Mixed Used Development

36 Argyle Street, Hobart Raadas Property Pty Ltd

36 Argyle Street
Alterations to
approved
development
Planning Report

PLN-16-1069 - 34-38 Argyle Street – Alterations to approved development Further Information

DA201.1 B

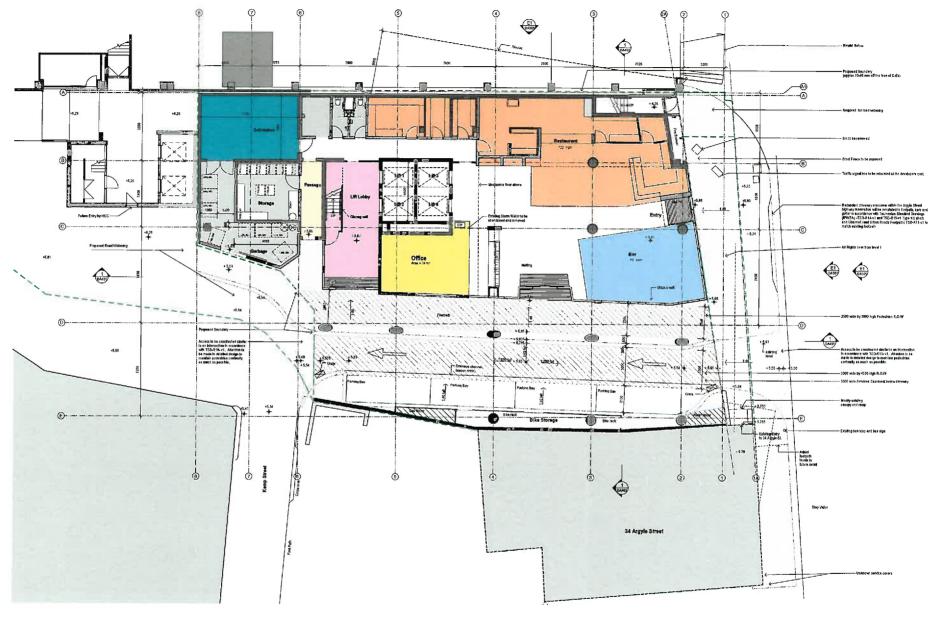
Sw 1 A concept servicing plan to demonstrate how stomwater from the proposed development (including roofed areas and impervious surfaces) will be disposed of via gravity to public stomwater infrastructure, taking into account the limited receiving capacity of the system.

Please provide a long section and several indicative cross-sections of the ROW between Kemp Street and Argyle Street, showing existing and proposed ground surface levels. Please show and clearly differentiate existing and finished surface spot levels through the site, especially along the low-side of the proposed RoW and at the intersection of the RoW with the low point in Kemp St.

ENGT FI 2	To ensure that the Council's road infrastructure is protected please provide:
	Infrastructure
	1. Show and label the location of infrastructure within the Argyle Street highway reservation adjoining the development, in particular the traffic box, bins and existing fencing for the car park.
	 State on the plan that the traffic signal box, bin and existing fancing within the Argyle Street highway reservation are to be relocated to the back of the flootpath along the building line or removed/placed underground at the developers cost.

S 87	The application proposes a public Right of Way and footway from Argyle Street to Kemp Street, however no details are provided showing where this will be located. Pleases show clearly on the Ground Floor Plan proposed boundaries for the Right of Way and Footway. Any building columns located on the footpath should be excluded from the right of footway. The proposed Right of Way and footway will need to be limited in height but no indication of these height limits is shown on the plans. Please clearly show on the ground floor elevations locations of the vertical height limit boundaries for the Right of Way and Footway.
	The application proposes a service easement within the proposed driveway but does not provide any location details or information regarding the beneficiary of the easement. The proposed horizontal and vertical boundance of the service easement will need to be shown on the Ground Floor Plan, suitable ground floor elevation and the easement beneficiary should be clarified.

Please see attached drawing DA201.2 showing concept stormwater drainage, connections and concept drainage for the driveway.

The proposed levels of the overland flow path from Kemp Street are shown on DA201.1 and DA403.

The attached plan DA201.1 shows existing infrastructure along Argyle Street in the vicinity of the development. The existing fence, traffic box and bin to be removed or relocated are marked on the plan. Please note that the use and development under this application will not impact on this infrastructure.

The attached plan DA201.1 and sections DA403 show the path of the proposed public vehicle and pedestrian right of ways.

The vehicle ROW is to be 3000mm wide and 4500mm high. The pedestrian footway ROW is to be 2500mm wide by 3000mm high (see DA201.1)

The proposed title boundaries and road widening are shown on DA201.1.
